RE: North Penn High School BP-2
Change Order Request #25 AV Wall Change ASI #16

ARCHITECT'S SUPPLEMENTAL INSTRUCTIONS (ASI) 16
CLASSROOM AV WALLS

To:	All Contractors
Project Name:	Additions and Renovations to: North Penn High School – Bid Package 2 (BP2) 1340 S. Valley Forge Rd. Landsdale, PA 19446
Prepared for:	North Penn School District 401 E. Hancock Street Landsdale, PA 19446
Date:	23 July 2026

Drawing Number:
BP2-A111.A2

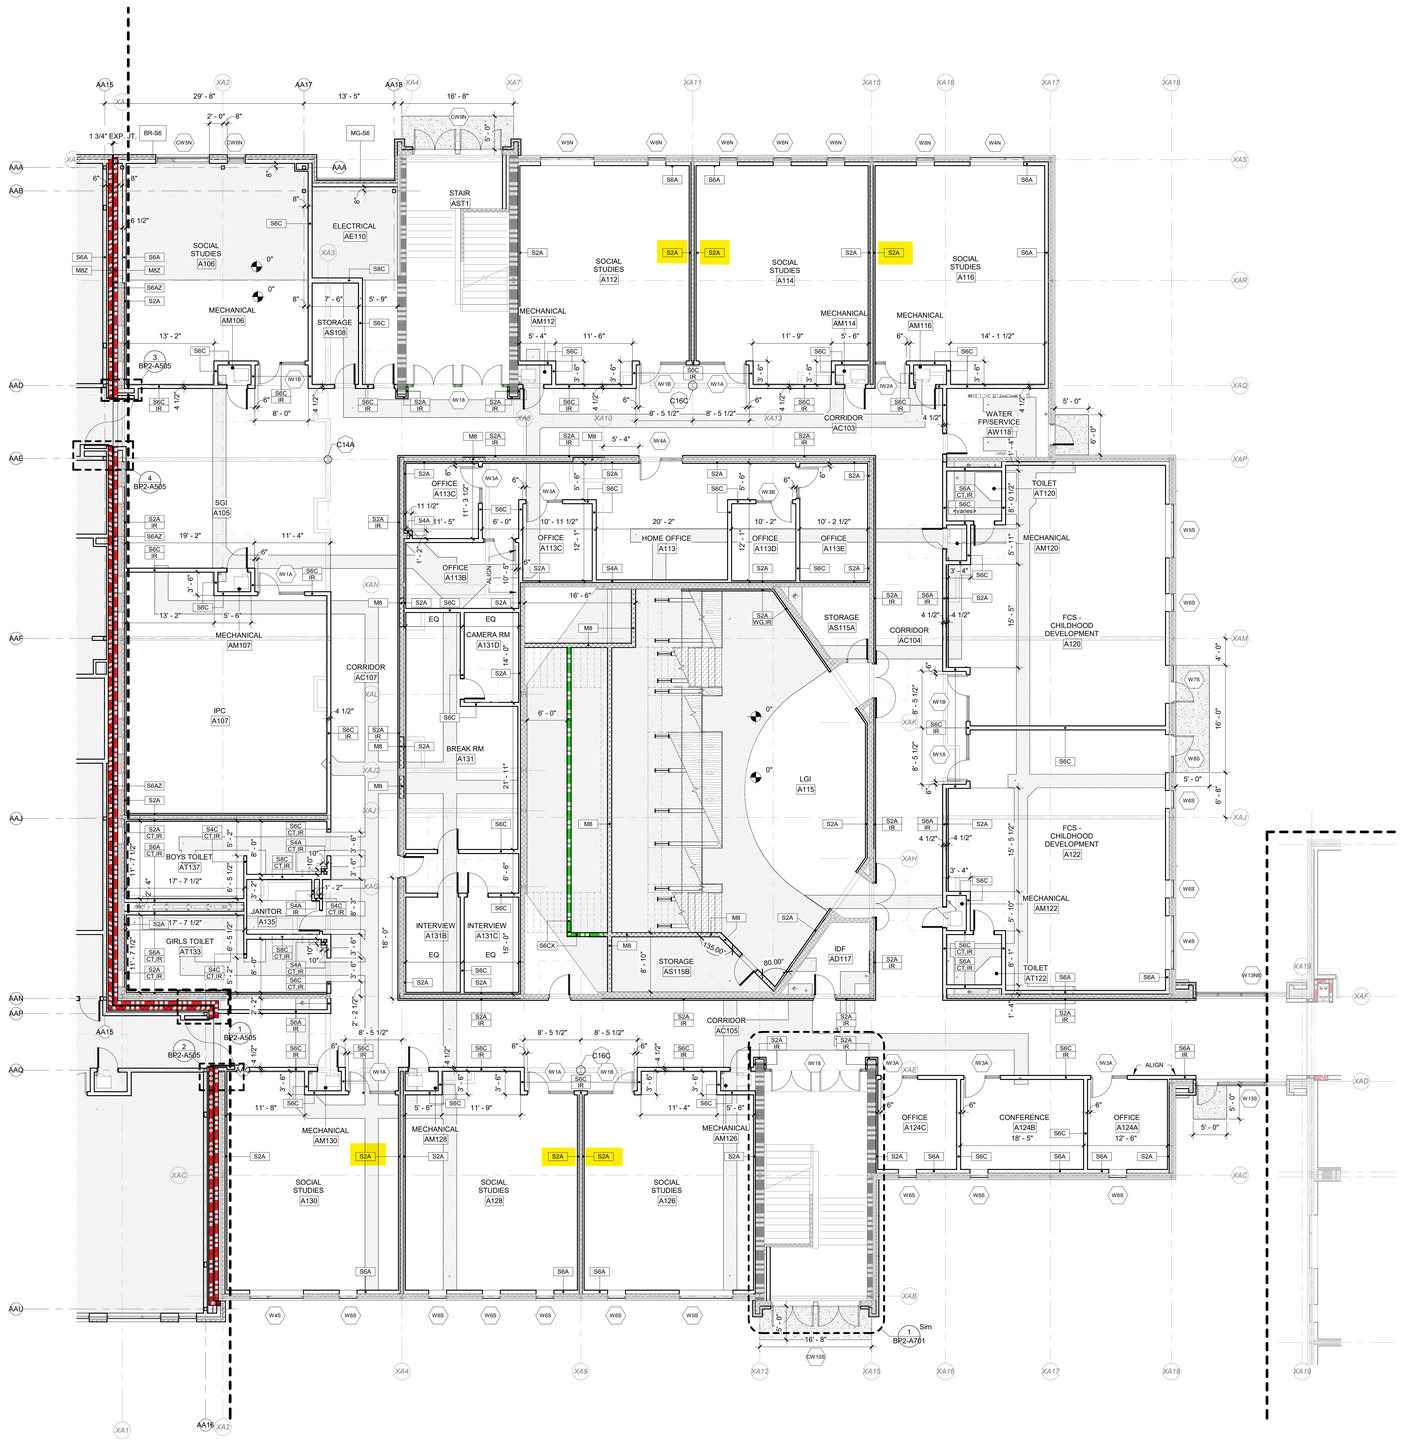
- **Swap 2-1/2" 20ga Metal Framing to 4" 20ga Metal framing at AV walls per note E on Power Drawings.**

16.01 Architectural BP2-A110 Series Drawings: Revise Classroom AV wall partition type to S4A in lieu of S2A.
